**MONTGOMERY COUNTY HISTORIC PRESERVATION COMMISSION**  
**STAFF REPORT**

<b>Address:</b>	7230 Spruce Avenue, Takoma Park	<b>Meeting Date:</b>	2/22/2023
<b>Resource:</b>	Contributing Resource <b>Takoma Park Historic District</b>	<b>Report Date:</b>	2/15/2023
<b>Applicant:</b>	Ryan Doyle (Agent)	<b>Public Notice:</b>	2/8/2023
<b>Review:</b>	HAWP	<b>Tax Credit:</b>	N/A
<b>Permit Number:</b>	1019756	<b>Staff:</b>	John Liebertz

**PROPOSAL:** Solar panel installation.

**Figure 2: View of the subject house from Spruce Avenue, ca. 1980s (left) and 2023 (right). The red arrow points to the location of the proposed solar array on the southern slope of the non-historic dormer.**  
**Source: Montgomery Planning.**

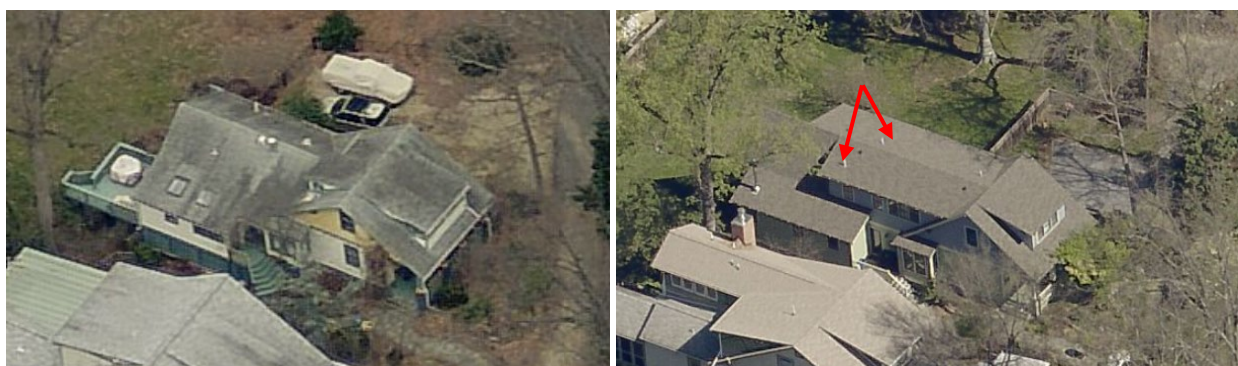
Staff finds that the proposal is consistent with the applicable guidelines. The use of a freestanding solar system is not possible due to the existing tree canopy, setback requirements, and lack of power generation. The property contains no accessory buildings (outbuildings, garages, etc.) which requires the installation of panels on the roof of the house. The proposed location of the panels on the non-historic shed dormers complies with the guidance (specifically Preference #3: Roof-mounted Solar Systems on Non-Historic Additions) outlined in *Policy Guidance #20-01: Solar Technology (2021)*. The dormer on the northern roof slope—that contains most of the panels—is not visible from any public rights-of-way (*Fig. 3*). Likewise, the dormer on the southern elevation—that contains 8 of the 23 panels—is obscured

from the public rights-of-way due to the shallow pitch of the roof, the setback of the panels from the edge of the roof, and the panel's location behind the historic side-gable massing (Figs. 2-3). While there are three Outstanding Resources with views of the subject property (Fig. 4), these views are from the rear of the respective resources and there would be limited visibility of the panels due to their placement. Staff finds that the panels will not adversely affect the streetscape.

SOLAR PANEL LAYOUT

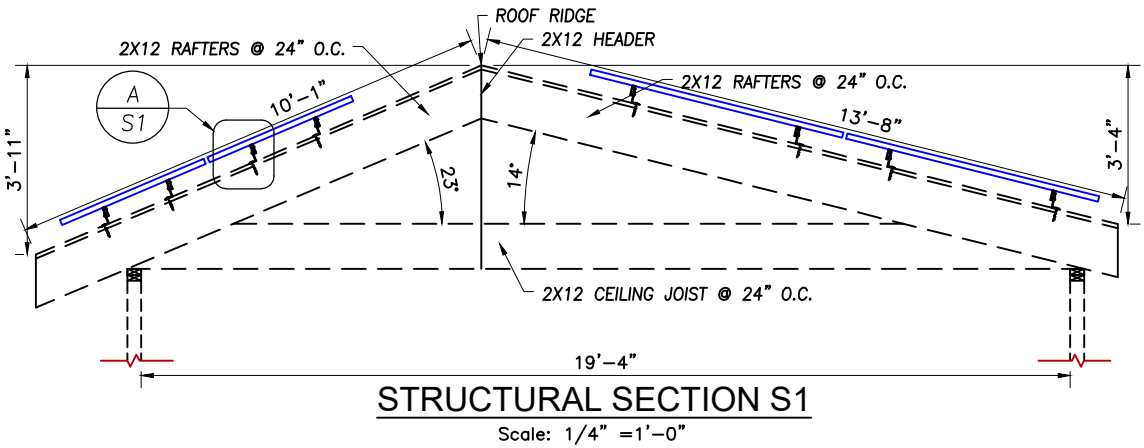
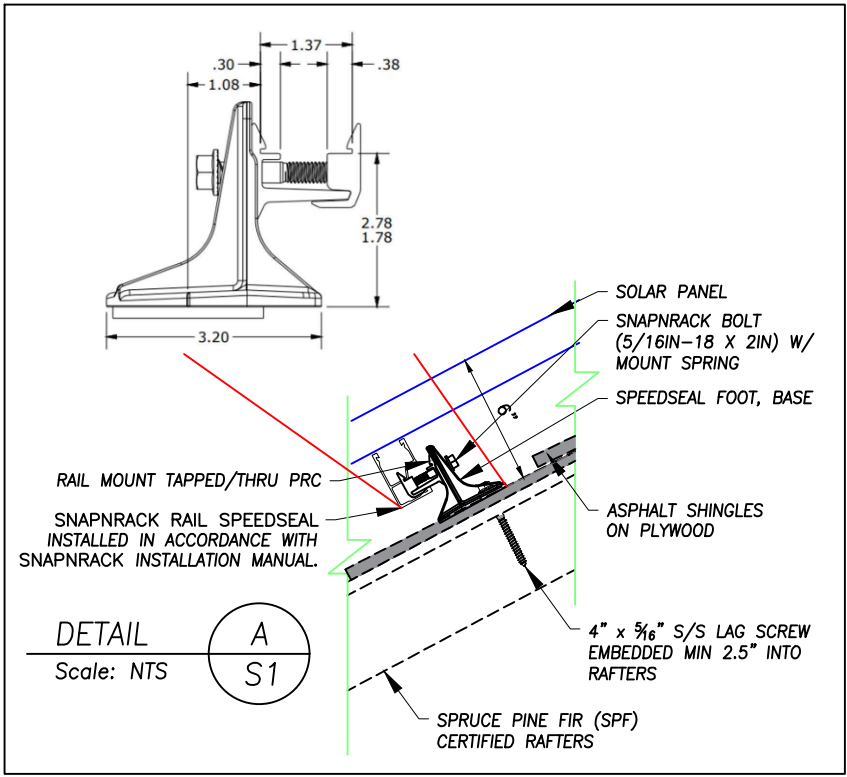
Staff finds that the proposed panels have an organized configuration, are mounted less than or equal to six inches above the surface of the roof (from the roof to the face of the panel) and follow the existing slope. In addition, the panels are setback appropriately from the edge and ridge of the roof. The panels are setback from the ridge and edge of the southern slope (visible from the public right-of-way) by 1’4” and 1’9”, respectively. All conduits are located within the attic. While the inverter is placed within view of the public right-of-way on the eastern extent of the southern elevation (near the front porch), it is adjacent to an existing utility meter and will not further diminish the integrity of the resource.
